E5071C-01 <u>S E R V I C E N O T E</u>

E5071C ENA Series Network Analyzer, 9 kHz to 8.5 GHz

When replacing Inverter Board and LCD, fasten the TORX T15 screws using a torque screwdriver (set to 1.02 N-m / 9.0 lb-in).

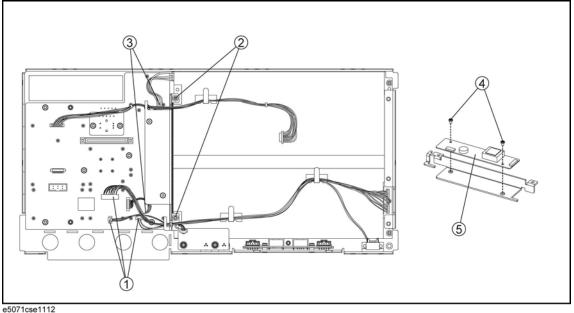
When replacing the Inverter Board and LCD, no torque info is shown in the service guide. If you fasten the screw with over the appropriate torque, A51 LCD might be damaged, and if you fasten the screw with under the appropriate torque, LCD module might not be fixed against the vibration.

When replacing Inverter Board, fasten the TORX T15 screws (item 2) using a torque screwdriver (set to 1.02 N- m / 9.0 lb-in).
